**RE: Baylor Drive Property
2635 Baylor Dr. SE
Grading and Drainage Plan
Engineer's Stamp Date: 10/16/20
Hydrology File: M16D044**

**RE: BAYLOR DRIVE PROPERTY
2635 BAYLOR DR. SE
GRADING AND DRAINAGE PLAN
ENGINEER'S STAMP DATE: 08/07/19
HYDROLOGY FILE: M16D044**

GRADING AND DRAINAGE PLAN

GR-1

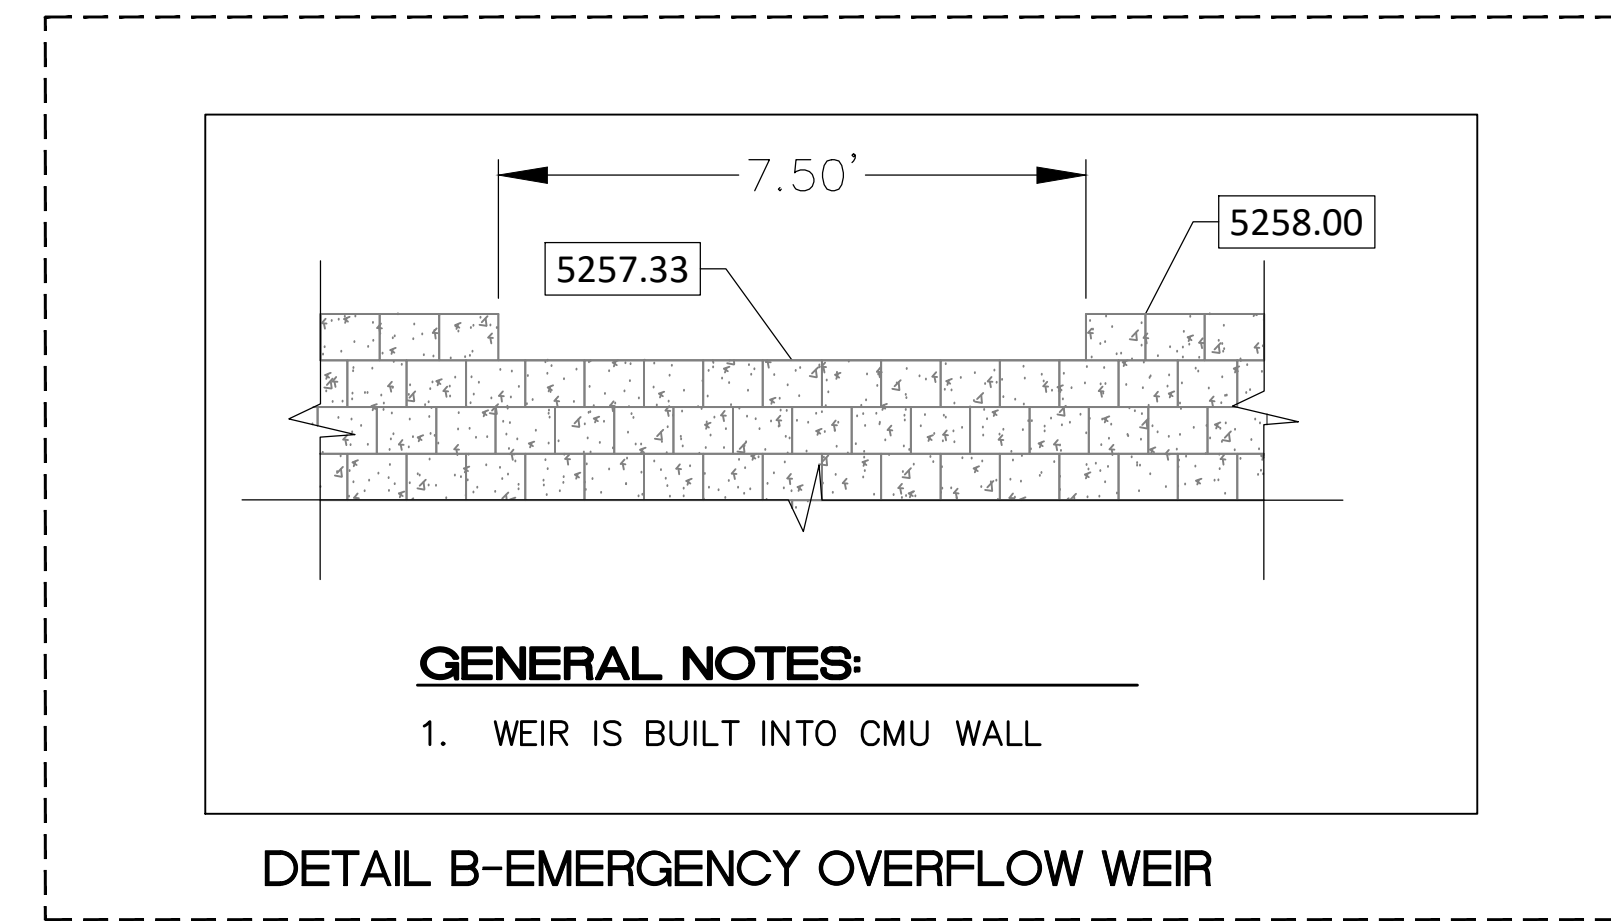
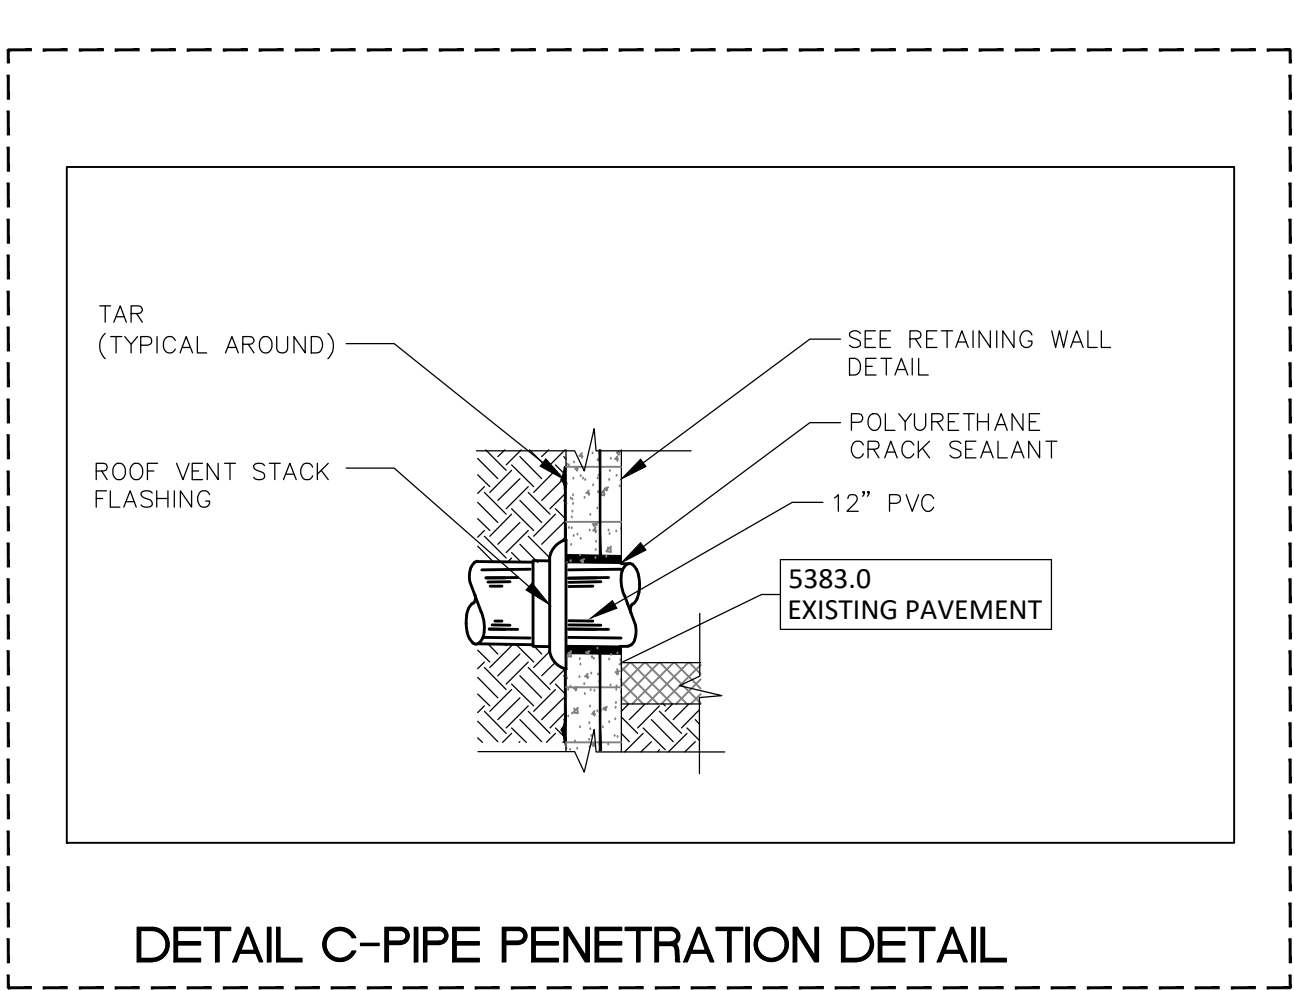
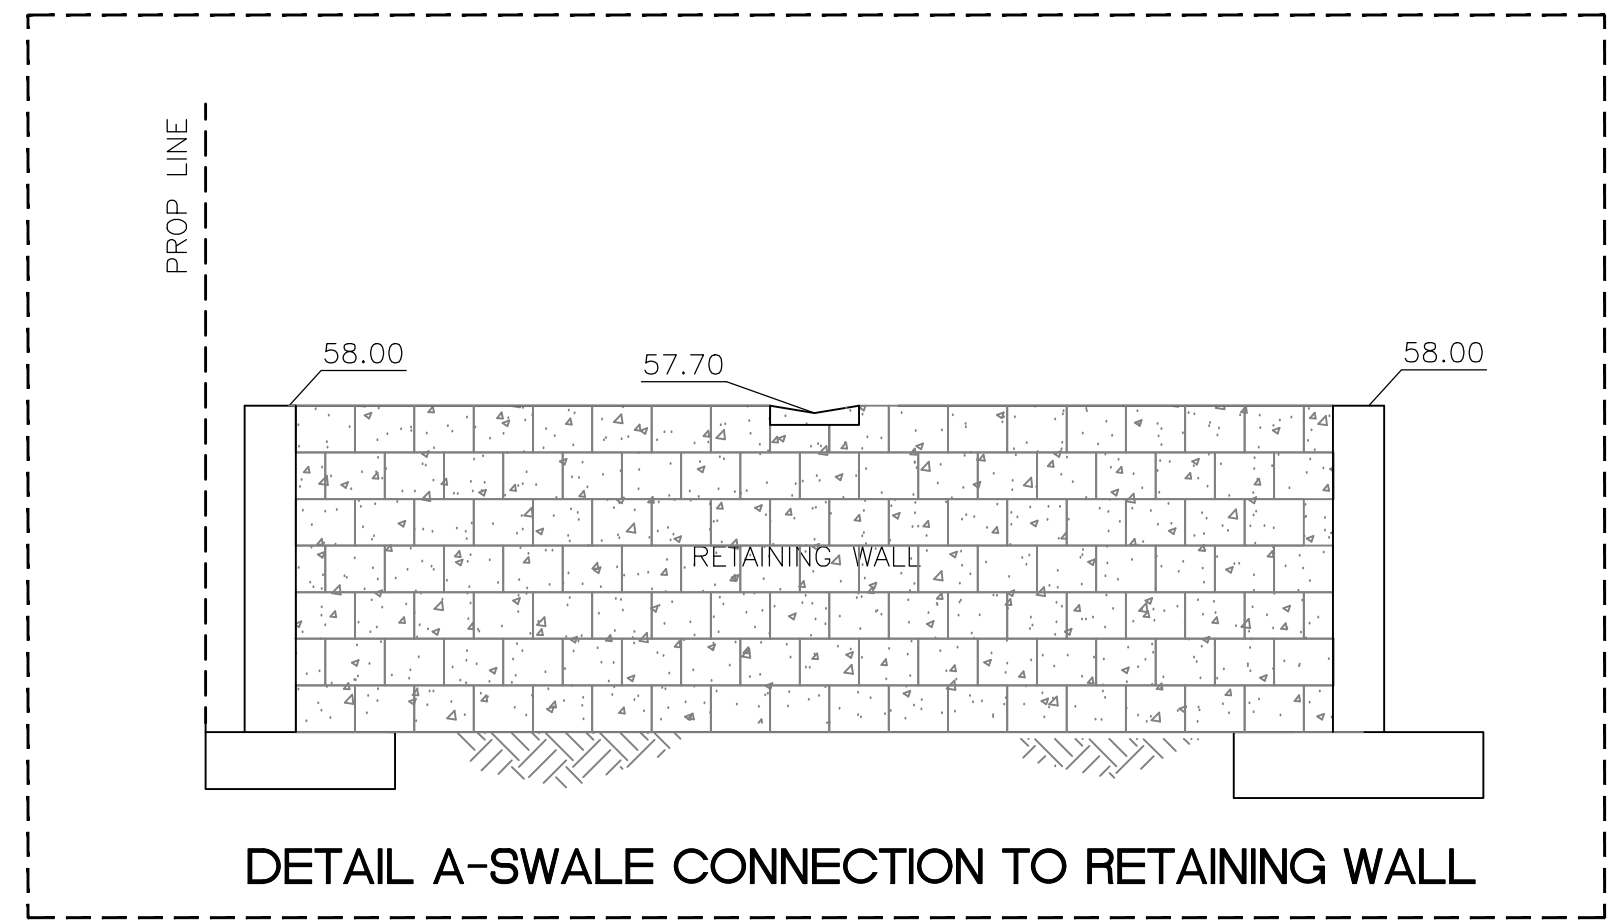
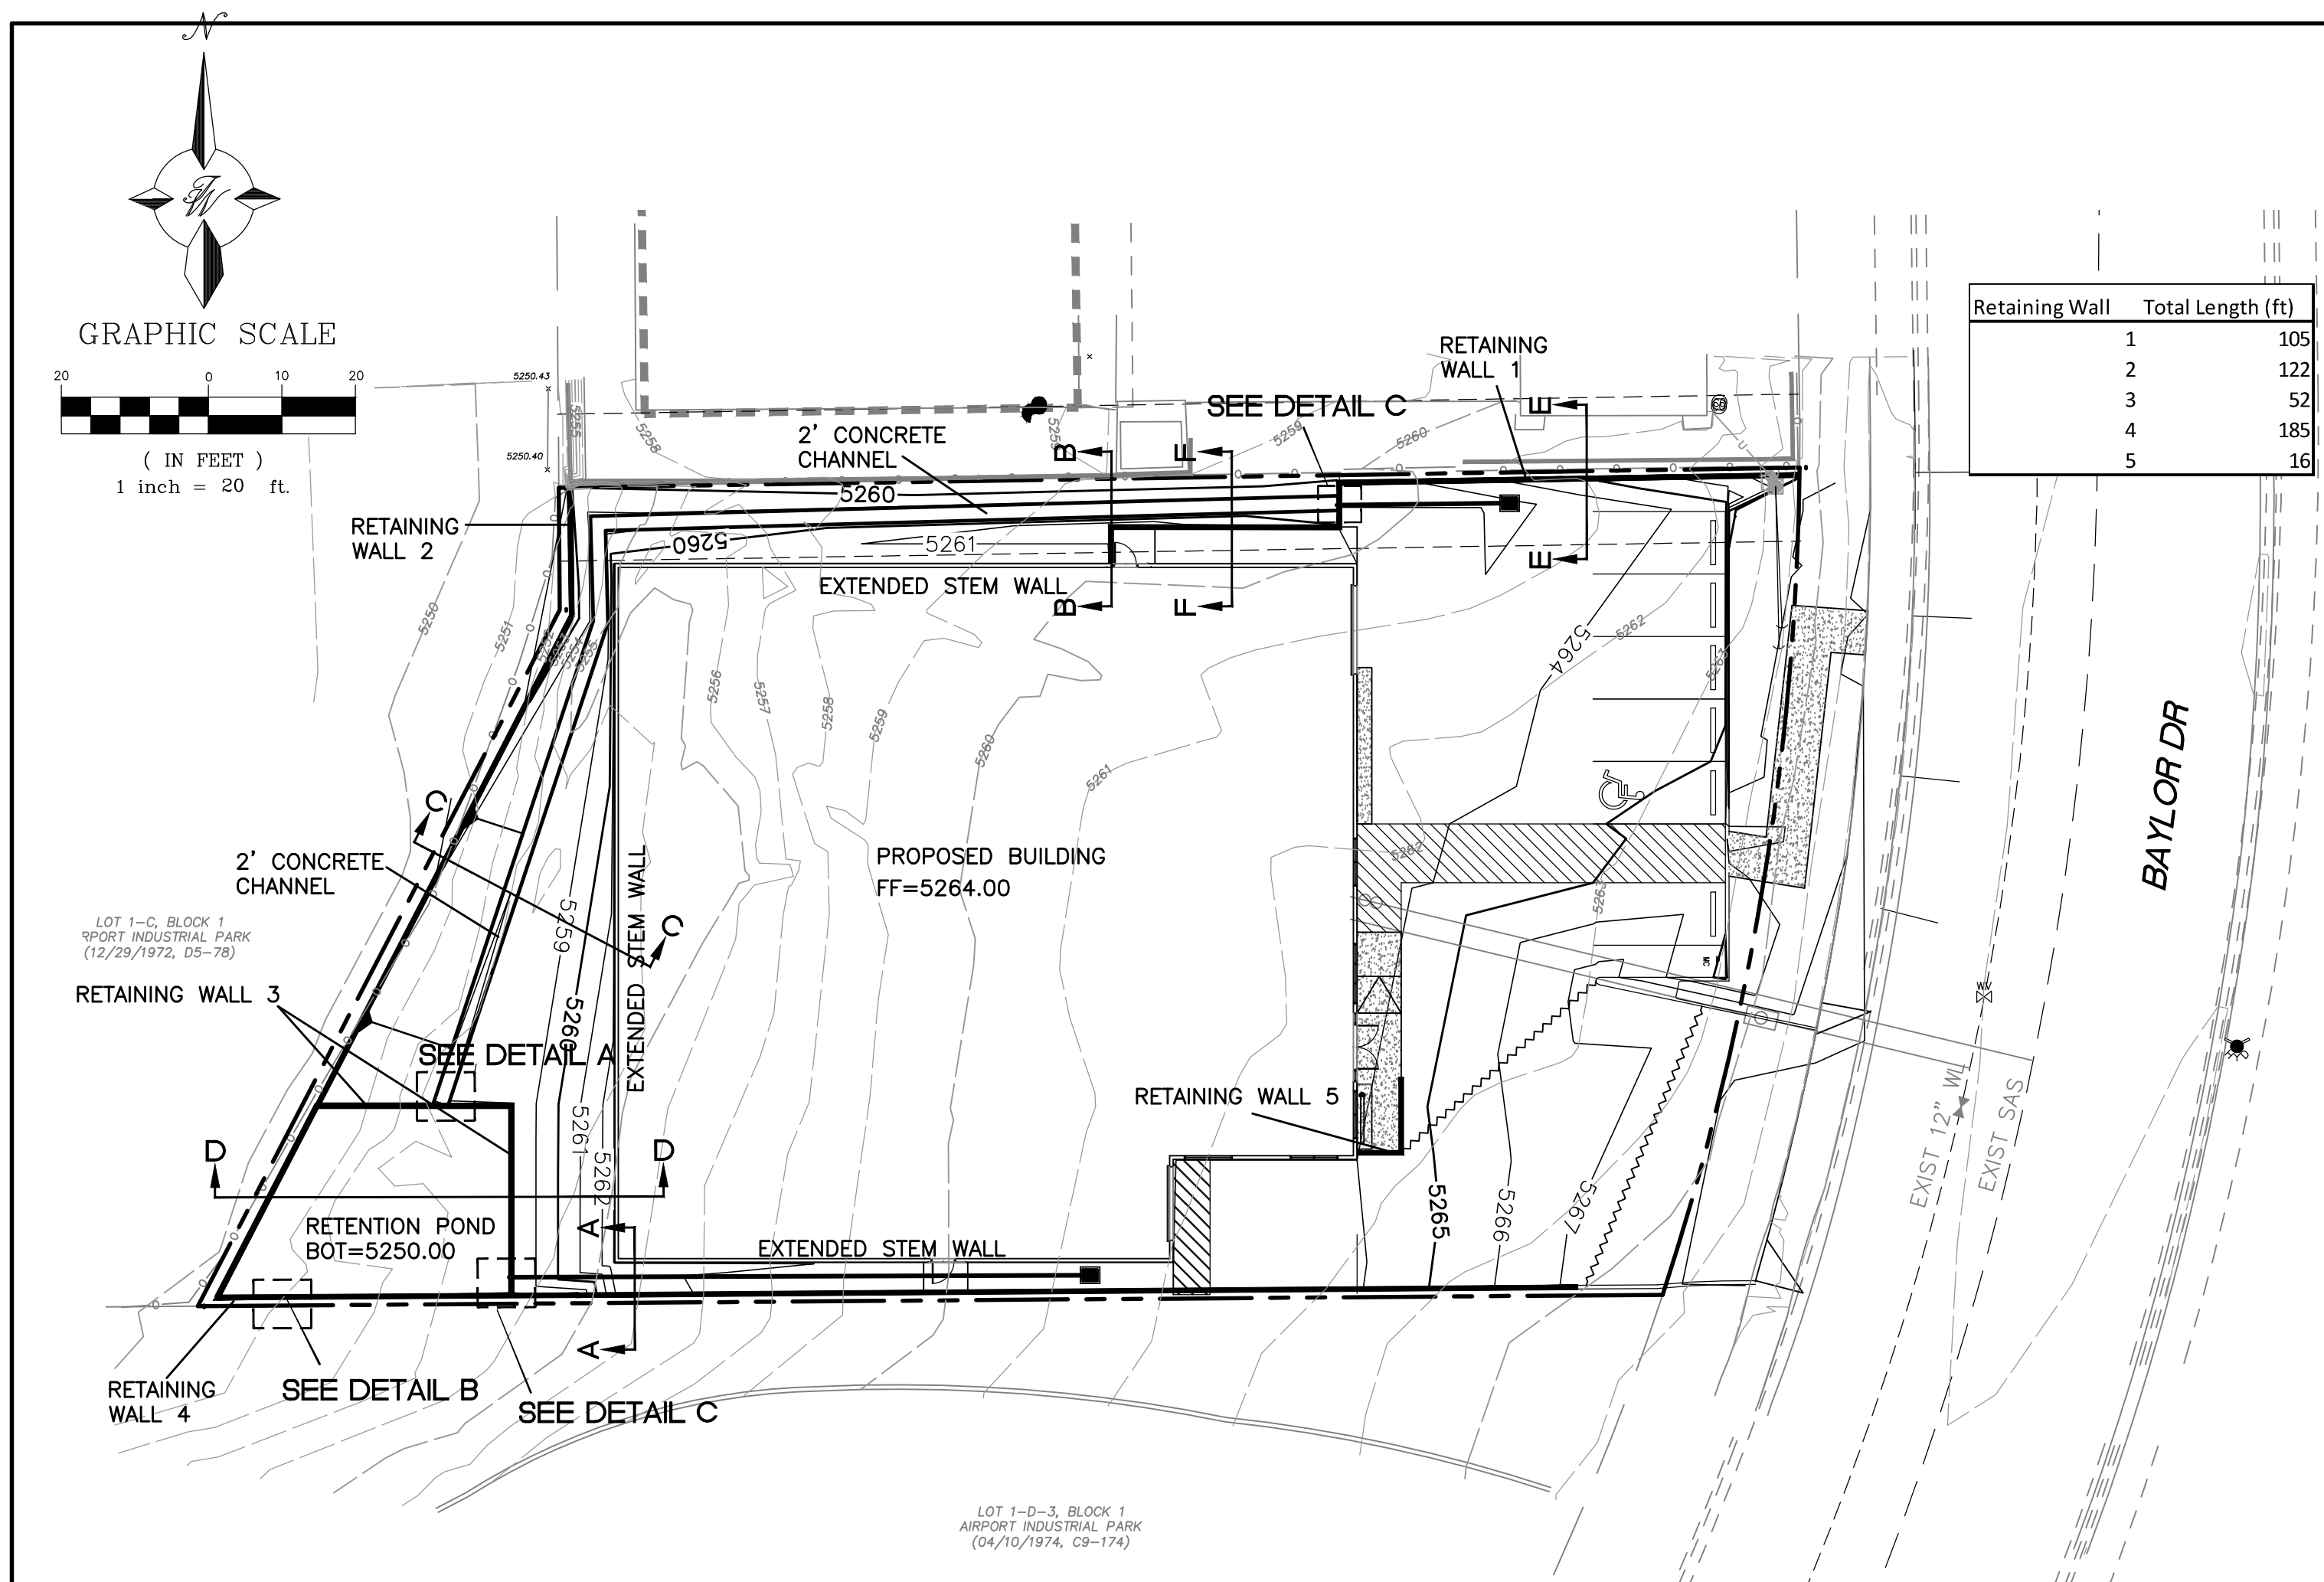
1. Provide the existing and / or proposed grades on both sides of the proposed retaining wall.
Response: Additional spots have been added adjacent to the proposed retaining wall.

6. Please fix several overlapping text and missed placed text.

Response: Overlapping text has been fixed.
